Technical Service Information

THM 4L80-E DELAYED UPSHIFTS IN 4WD LOW

Figure 1

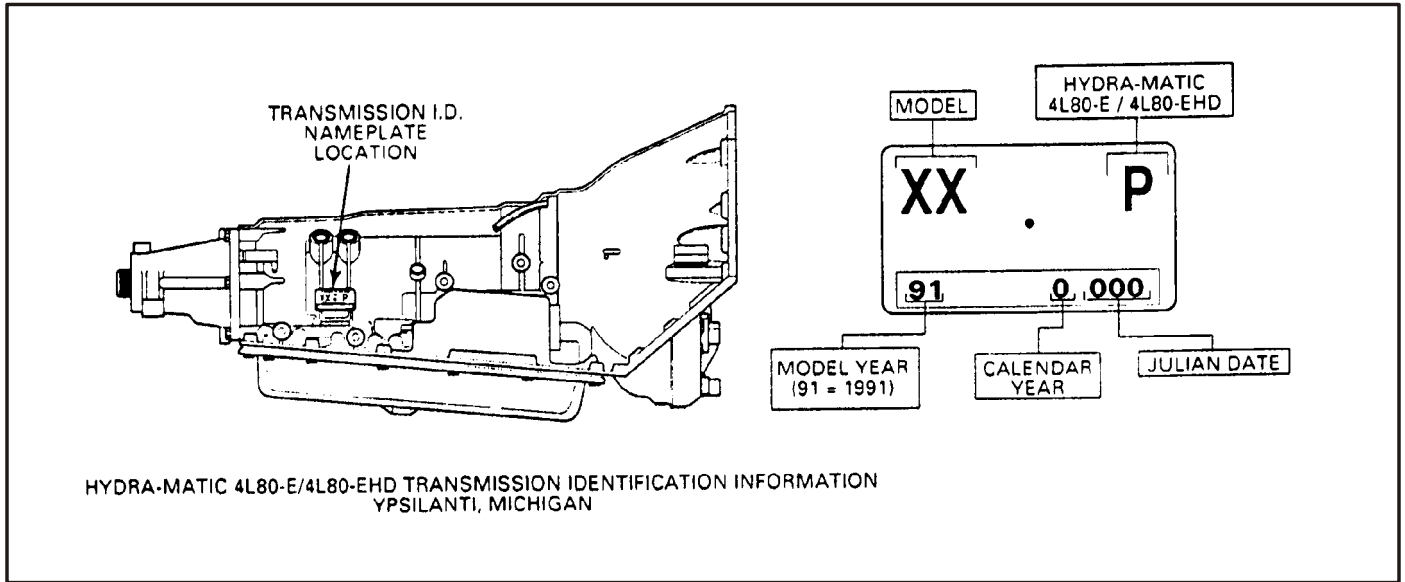
CORRECTION: A new PROM for the PCM/TCM has been released for all K and V trucks. Check the broadcast code on the current PCM/TCM and install the proper part number new PROM, selected from the Service Information listed below.
Beginning on January 15, 1991 (Julian Date 015) all ACP, BJP, CKP, and DLP transmission model applications were built with the new PROM. Use Figure 1 for Julian Date location, to determine if your vehicle needs the new PROM installed.
